Paragraph No. 19..
from DRK Covering
Letter in Application
No. 2021/5620/P. §
A New & audacious,
Contentious, claim
"THESE FINS
WOULD NOT
OVERSAIL ANY
NEIGHBOURING
LAND"..?

Summary of Objection to 2021/5620/P - Same old Fins Cladding - presented again without mentioning any!

Herewith a recent
photograph.. taken

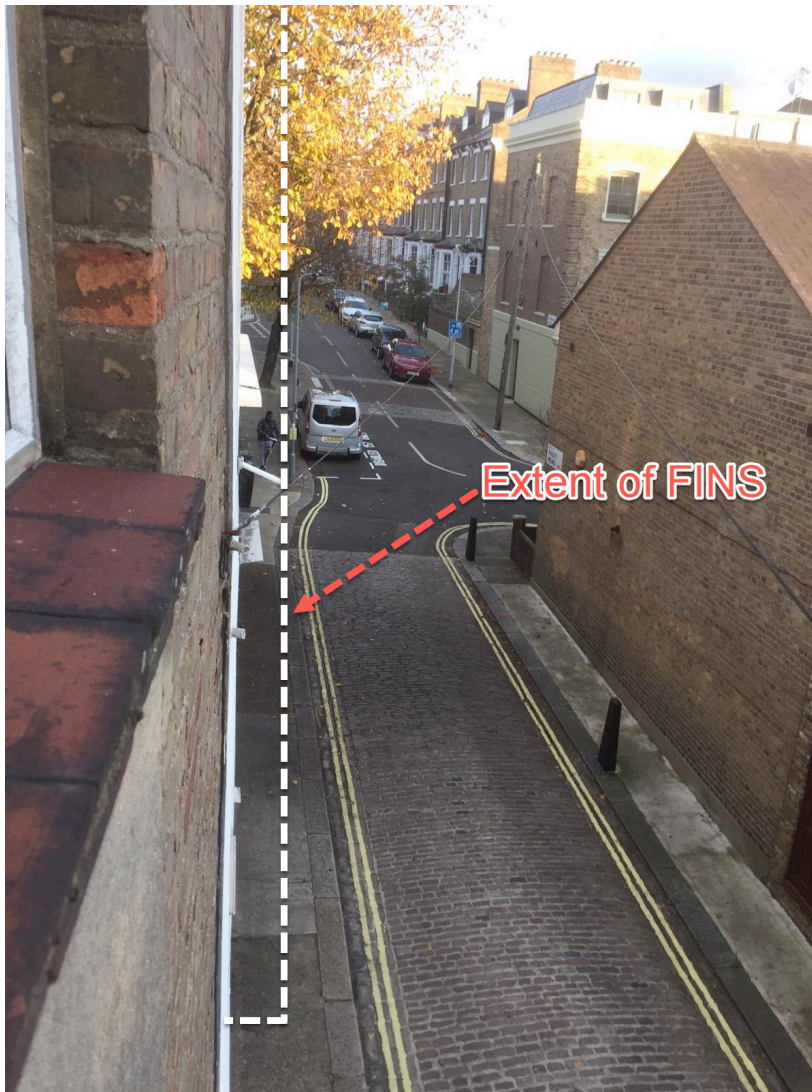
**& IT'S PERFECTLY
OBVIOUS THAT
FINS WOULD
OVERSAIL THE
MEWS AS WELL!**

from my window at No.16 looking east towards Ospringle St. at junction
with Leverton & Lupton Streets. These FINS block my view of CORNER &

Or see any VISITOR & Meds DELIVERY.* A valuable amenity to me is lost.
(*Spot a little man, on the pavement?) & Drawn to scale on boundary line
